**ANP-10315 —U.S. EPR
Surveillance Testing and
TELEPERM XS
Self-Monitoring Technical
Report Markups**

U.S. EPR **Protection System** Surveillance Testing and TELEPERM XS Self-Monitoring

ANP-10315NP
Revision ~~2~~**4**

RAI 505
Question 07.01-44

Figure 2-1—U.S. EPR PS Testing Philosophy Overview

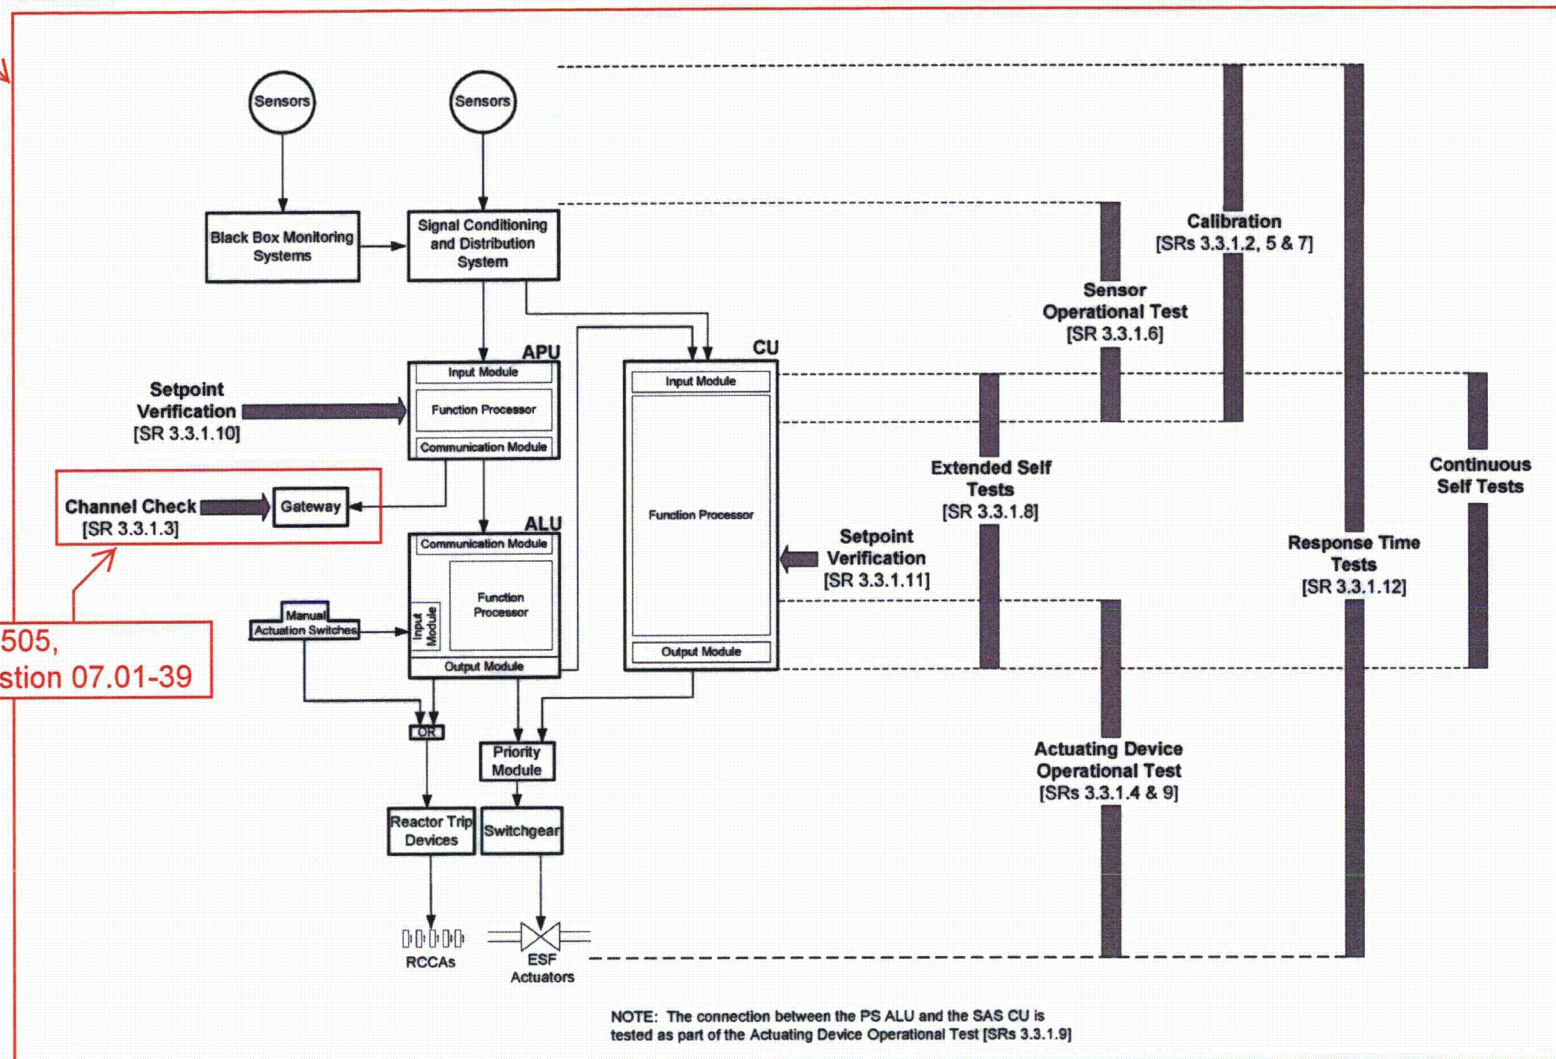
Figure 2-1 represents the U.S. EPR safety-related I&C systemsPS overlap testing philosophy and shows which portions of the safety-related I&C systemsPS are periodically tested through technical specification surveillance requirements, and which parts are continuously tested through self-monitoring features.

This section addresses each of the various overlapping tests shown in Figure 2-1, identifies the system equipment covered by each test, and provides information about how the testing is generally performed. Specific testing strategies and procedures will be developed by each COL applicant referencing the U.S. EPR standard design. A COL applicant may choose to perform a surveillance testing alternative from those described in this section. Descriptions of how testing is performed in this section are

Figure A-1—DAS Testing

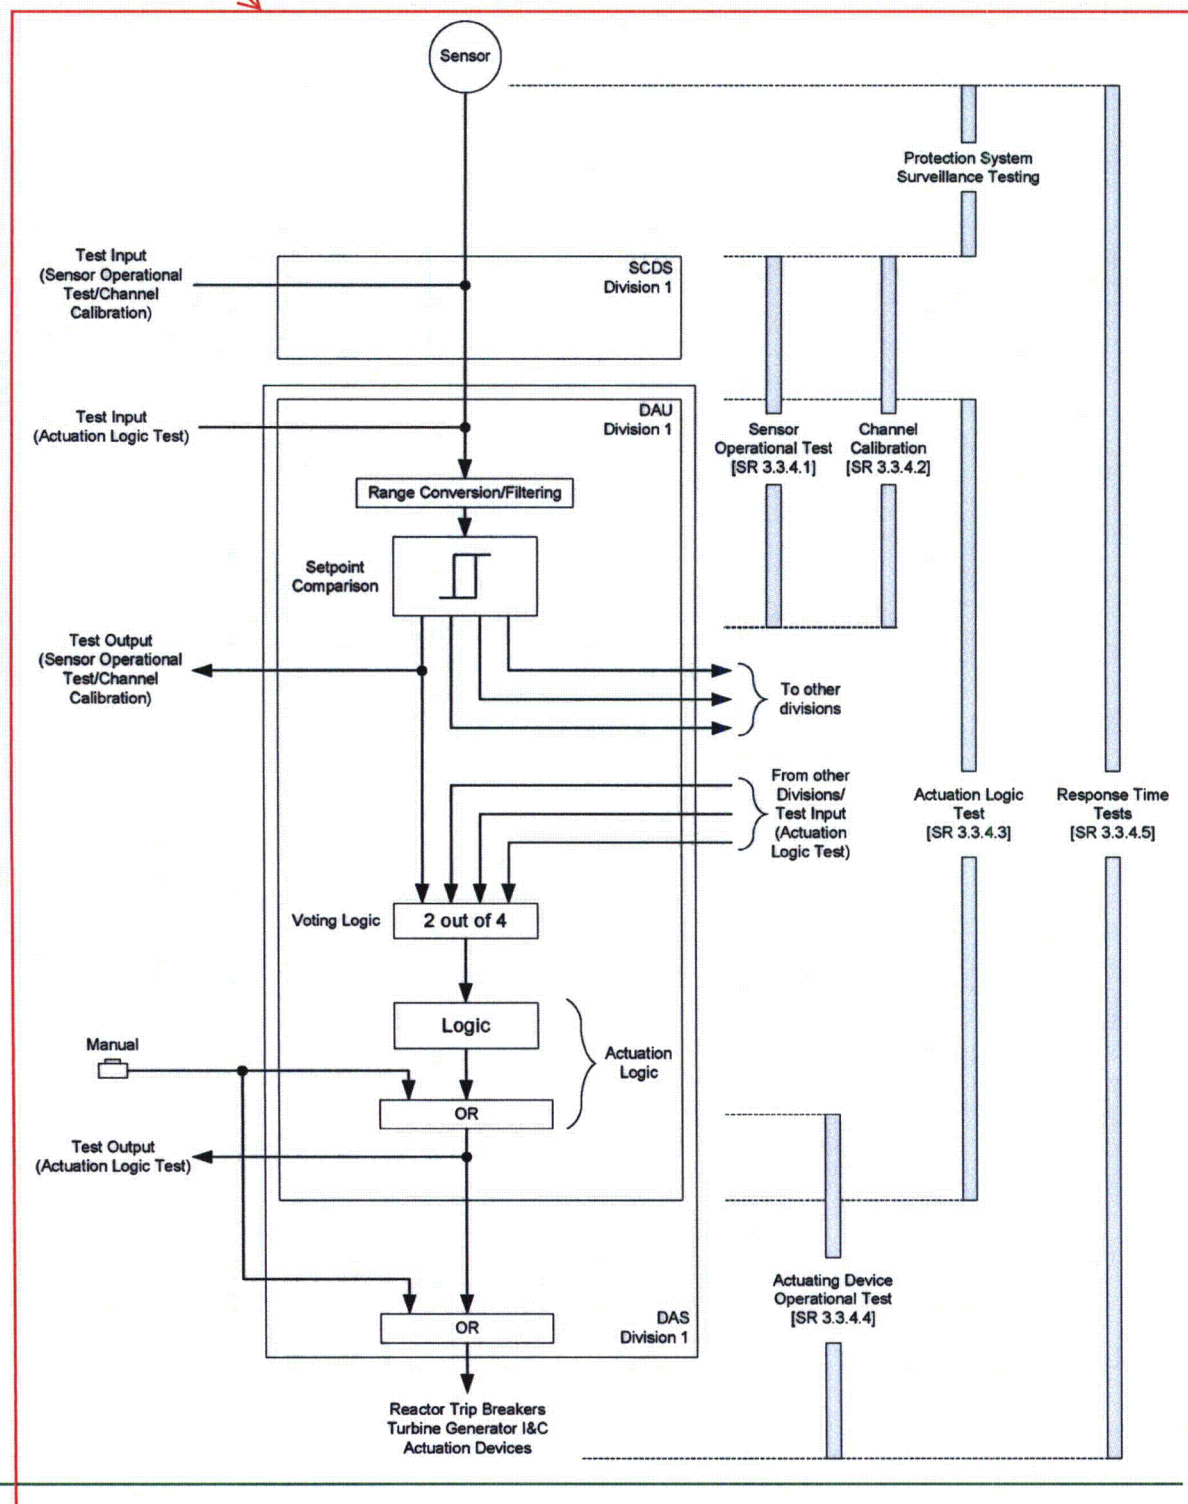
Figure A-1 represents the U.S. EPR DAS overlapping test philosophy, and shows which portions of the DAS are periodically tested to meet the surveillance requirements. This figure also shows the general concept for each test. Sensors shared by the protection system (PS) and DAS are tested as part of the PS. These sensors are not tested separately as part of the DAS periodic testing.
